AITKIN COUNTY CERTIFICATE OF INSTALLATION/NOTICE OF NONCOMPLIANCE

SUBSURFACE SEWAGE TREATMENT SYSTEM INSPECTION FORM AITKIN COUNTY, MINNESOTA

DRAWING OF SYSTEM: (include soils)

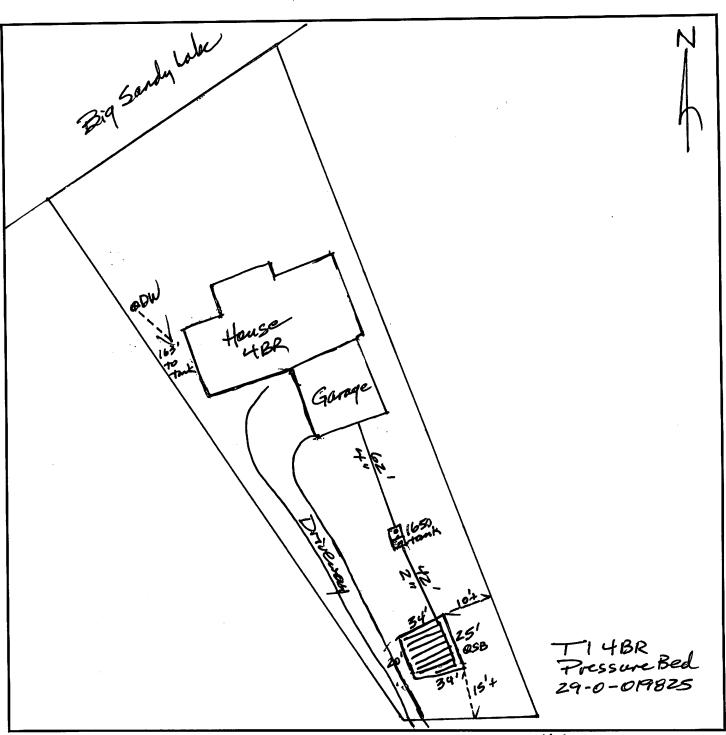
Inspector's Comments: Se Corner of pb.	1 67 4"	because berm of heavier soils on A	<u> </u>
Inspector's Signature	Bryan Hargrave	Installer's Signature_	
Rev: 1/13	White - County	Volley, Application Black and	—
